**RE: Mary River Project - Changes to Surveillance Network Program (SNP)  
Type 'A' Water Licence 2AM-MRY1325 - Amendment No. 1**

MARY RIVER PROJECT

MINE SITE  
WATER LICENCE MONITORING LOCATIONS  
POST CHANGE

Figure 1 – Milne Port – Drainage and Water Licence Monitoring Locations

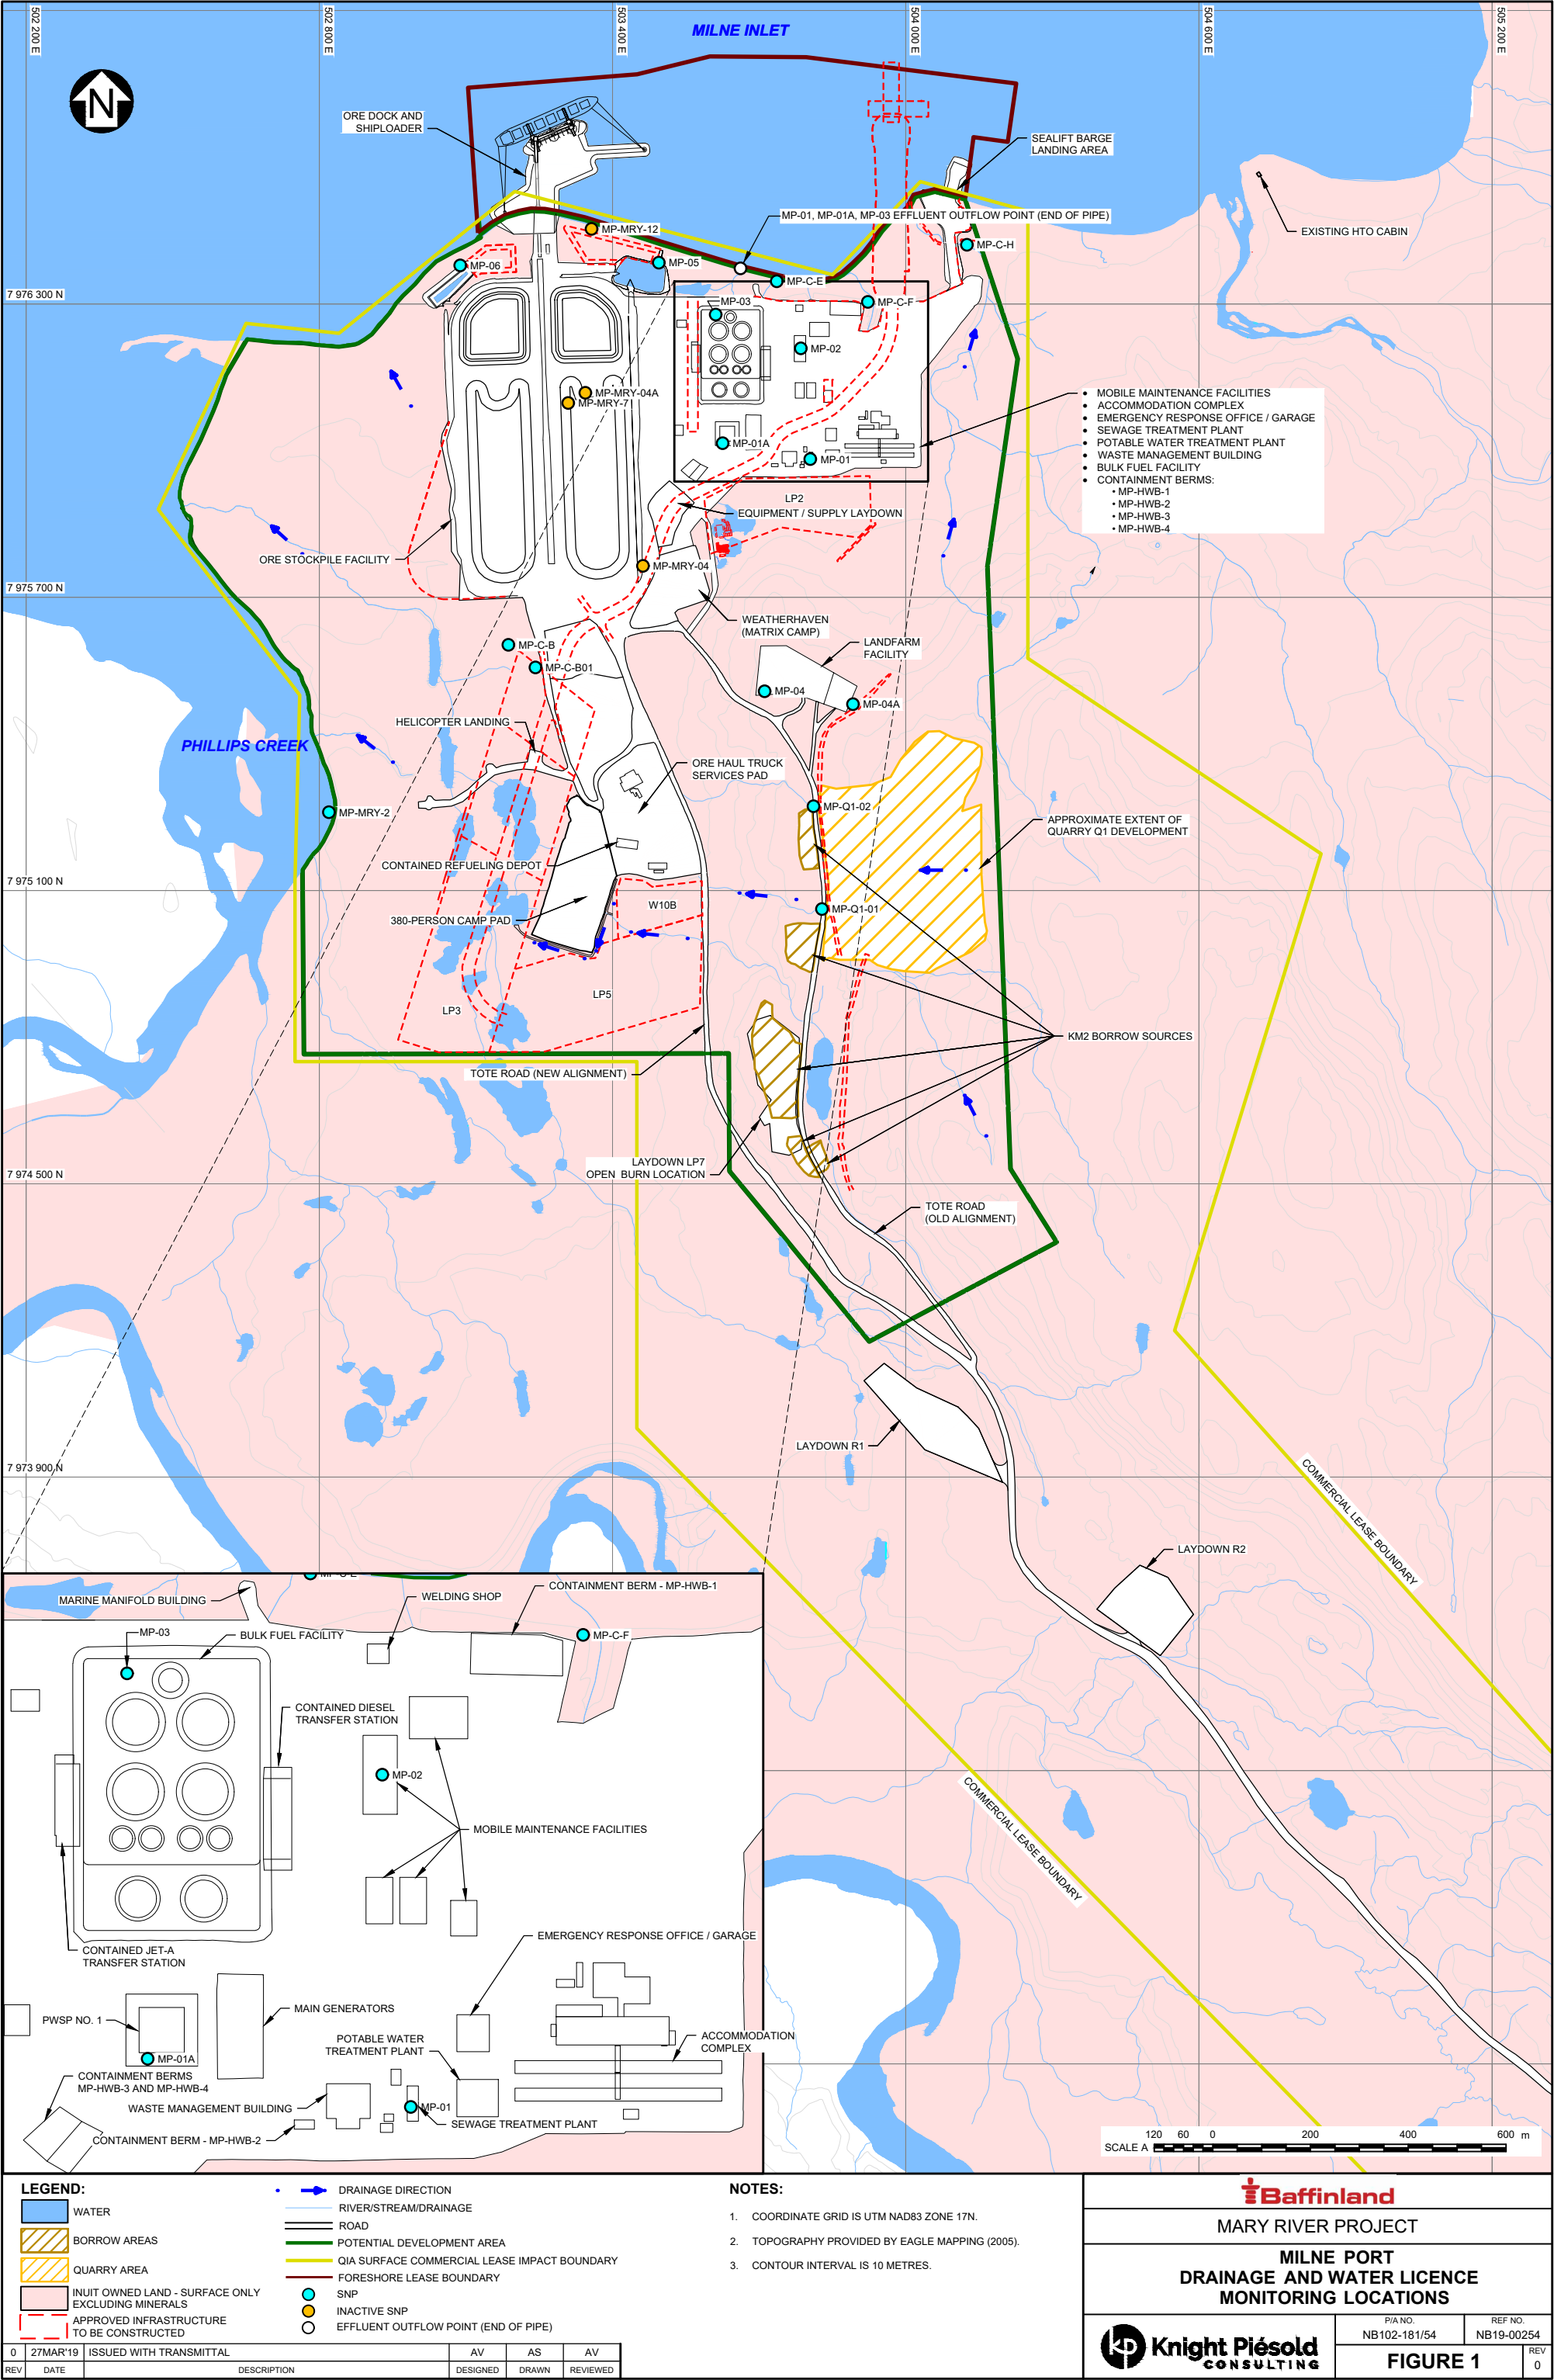
| Station ID        | Station Description   | Proposed Change   | Reason for Change   |
|-------------------|---|---|---|
| MP-MRY-4          | Milne Port Exploration Phase Sewage Treatment Facilities                      | Discontinue monitoring station. Remove monitoring station from Table 13 (Schedule I). | The Milne Port Exploration Phase Sewage Treatment Facilities have been decommissioned and are no longer in operation at the Project. Treated sewage effluent is currently discharged from SNP Station ID MP-01. |
| MP-MRY-4A         | Milne Port Exploration Phase Sewage Polishing Waste Stabilization Pond (PWSP) | Discontinue monitoring station. Remove monitoring station from Table 13 (Schedule I). | The Milne Port Exploration Phase PWSP has been decommissioned and is no longer in operation at the Project. Effluent from the ERP PWSP is currently discharged from SNP Station ID MP-01A.                      |

| Station ID        | Station Description   | Proposed Change  | Reason for Change  |
|-------------------|---|--|--|
| MP-MRY-7          | Milne Port Exploration Phase Bladder Fuel Storage Facility - Stormwater   | Discontinue monitoring station. Remove monitoring station from Table 13 (Schedule I).  | The Milne Port Exploration Phase Bladder Fuel Storage Facility has been decommissioned and is no longer in operation at the Project. Fuel at Milne Port is currently stored at the Bulk Fuel Storage Facility, monitored under SNP Station ID MP-03.   |
| MP-MRY-12         | Milne Port Bulk Sample Stockpile Area - Surface Water Drainage/Seepage    | Discontinue monitoring station. Remove monitoring station from Table 13 (Schedule I).  | Exploration Phase ore stockpiles associated with MP-MRY-12 have been removed and/or capped as a result of ERP construction and development at Milne Port. As shown in Figure 1, surface flows once monitored by MP-MRY-12 are now captured and retained by surface water management ponds associated with the Milne Port Ore Stockpile Facility. The Facility's surface water management ponds are monitored under existing SNP Station IDs MP-05 and MP-06.               |

| FIGURE 2                |                       |

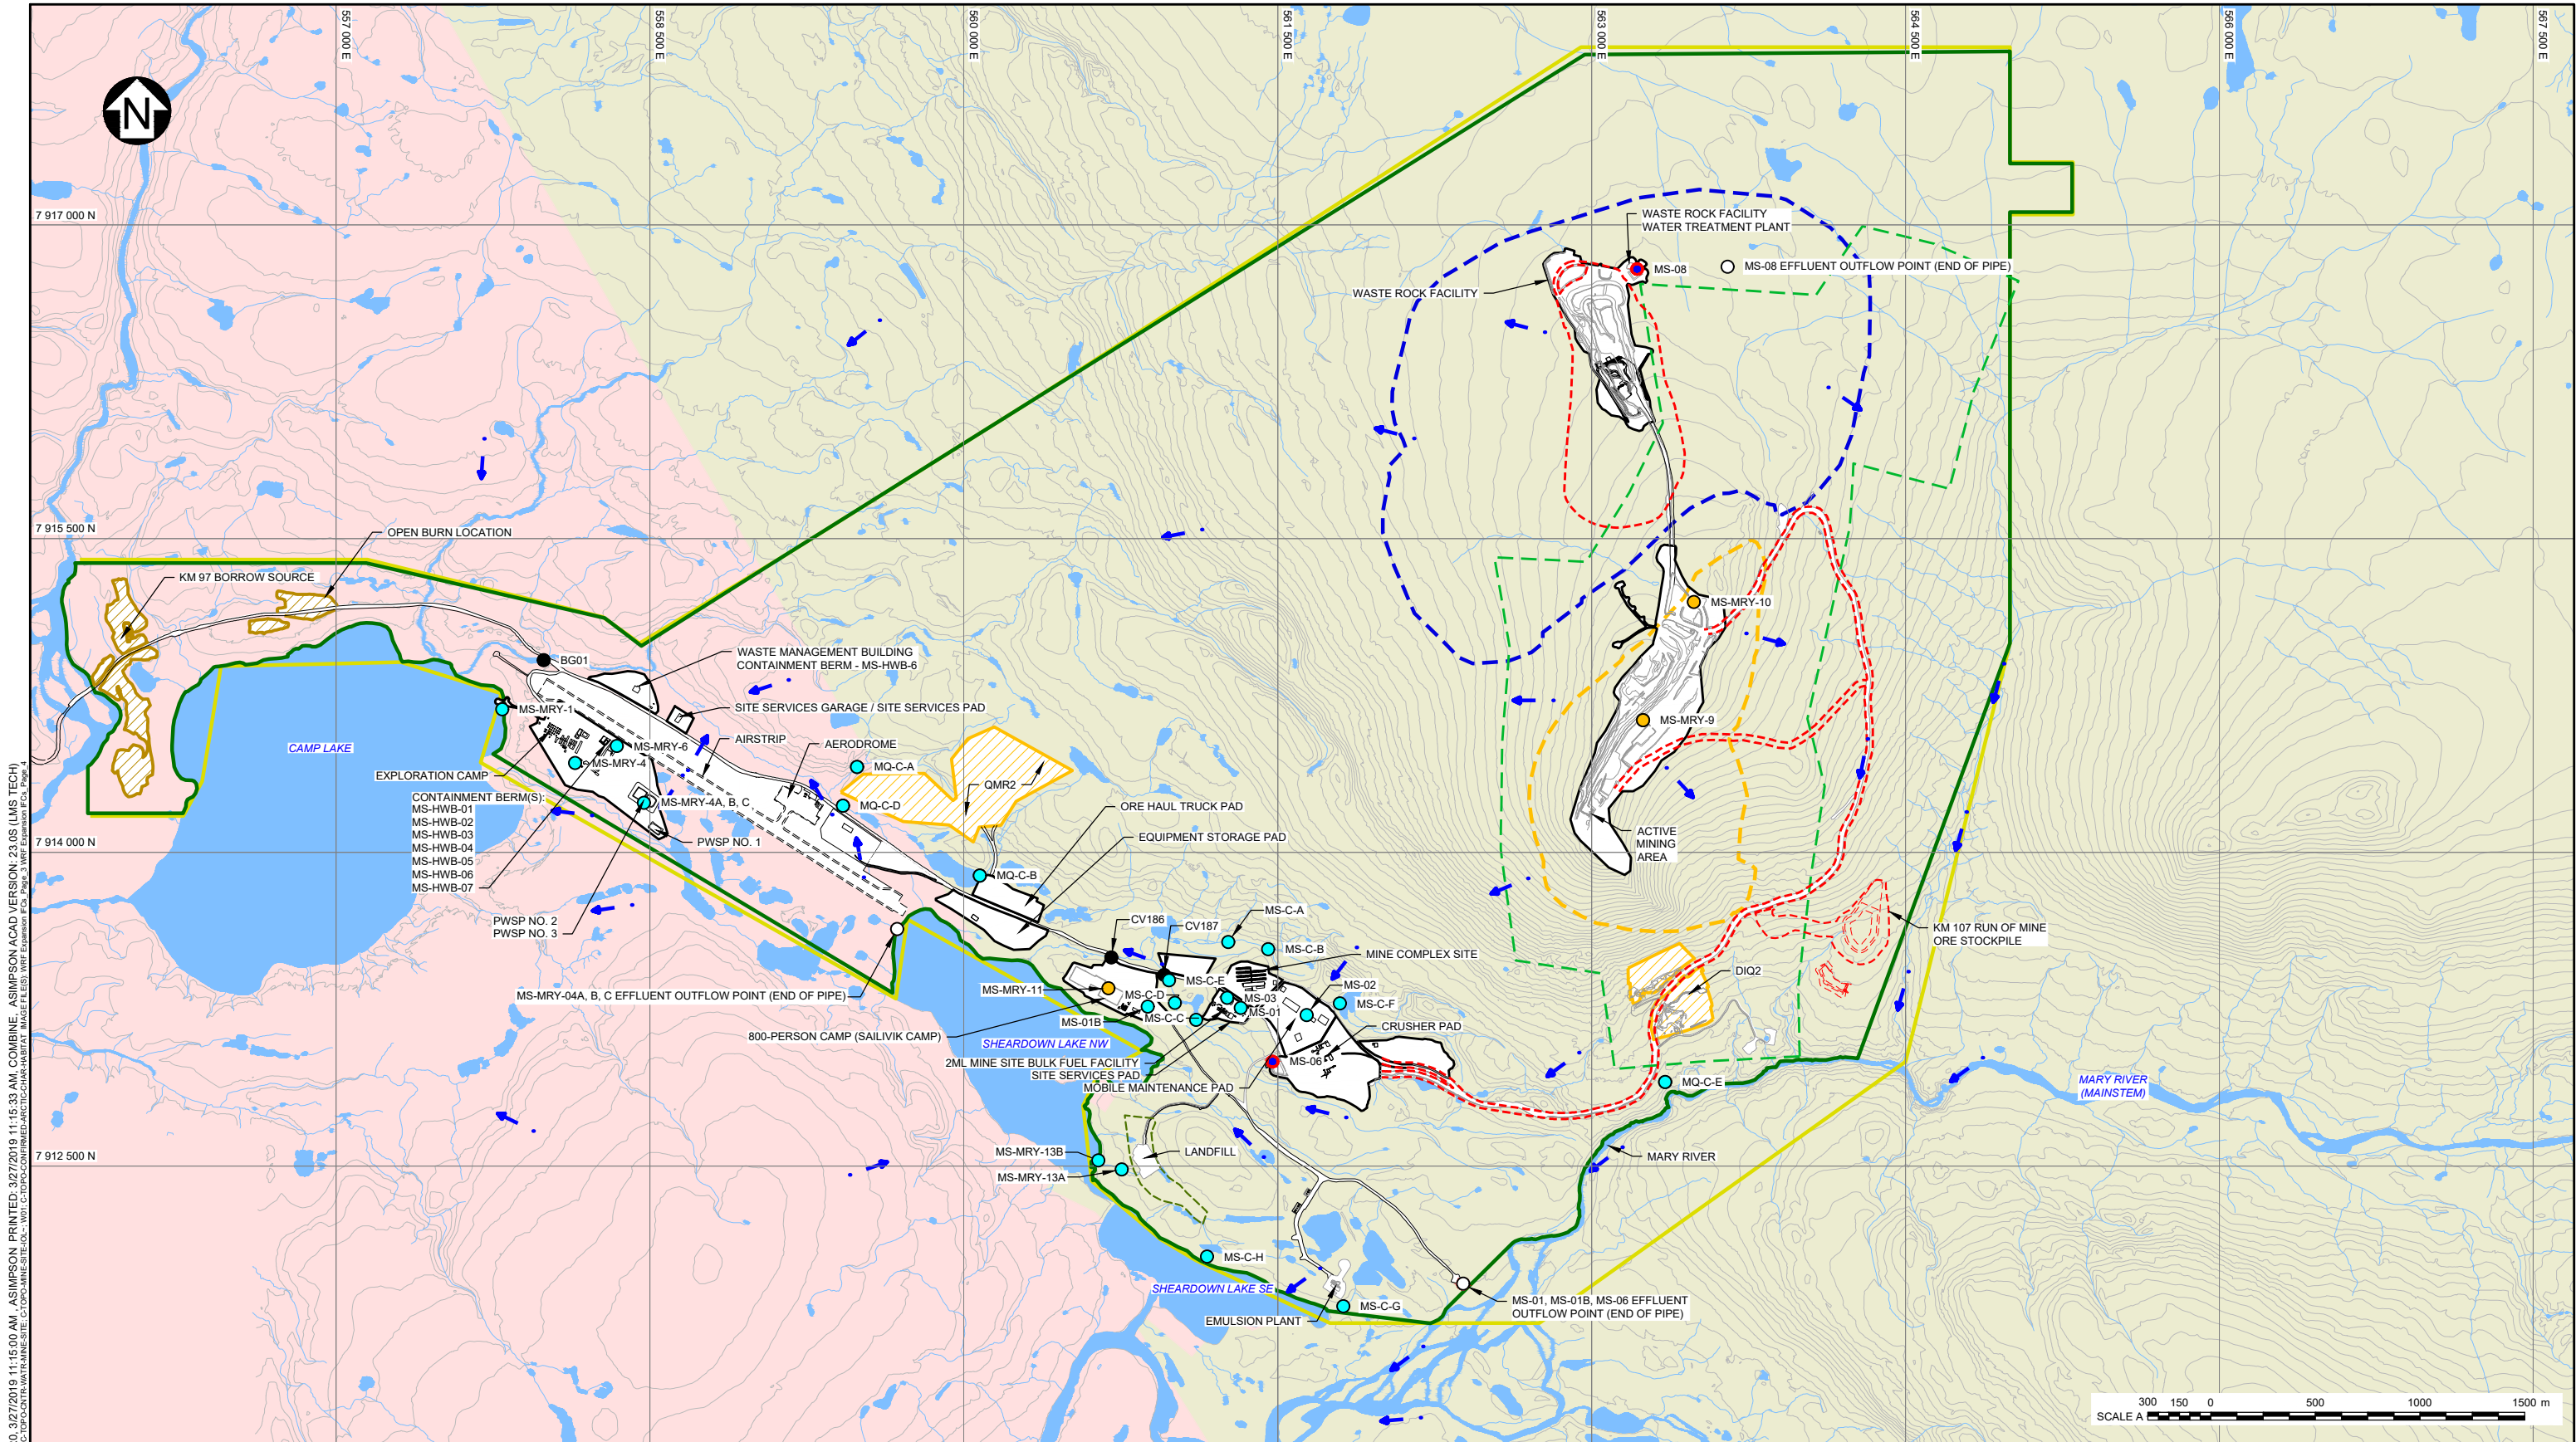
| Station ID        | Station Description   | Proposed Change  | Reason for Change  |
|-------------------|---|--|--|
| MS-MRY-9          | Bulk Sample Open Pit – Surface Water Drainage                             | Change location of monitoring station to monitor Deposit No. 1 surface water drainage. Change station description in Table 14 (Schedule I). <sup>1</sup> | Continued active mining within the Deposit No. 1 pit area has resulted in the lack of flows at MS-MRY-9. The proposed new location for MS-MRY-9 will allow for the long-term monitoring of Deposit No. 1 surface water drainage.   |
| MS-MRY-10         | Bulk Sample Weathered Ore Stockpile – Downstream Surface Water Drainage   | Change location of monitoring station to monitor Deposit No. 1 surface water drainage. Change station description in Table 14 (Schedule I). <sup>1</sup> | Exploration Phase ore stockpiles associated with MS-MRY-10 have been removed. The area associated with MS-MRY-10 has been repurposed as a laydown to support ERP mining operations at Deposit No. 1. The proposed new location for MS-MRY-10 will allow for the long-term monitoring of Deposit No. 1 surface water drainage and will be located with the highlighted area identified in Figure 3. Exact location of MS-MRY-10 will be assessed during the summer of 2019. |
| MS-MRY-11         | Bulk Sample Processing Stockpile Area – Downstream Surface Water Drainage | Discontinue monitoring station. Remove monitoring station from Table 14 (Schedule I).  | Exploration Phase ore stockpiles associated with MS-MR-11 have been removed. The area associated with MS-MRY-11 has been repurposed as a laydown to support ERP operations.  |
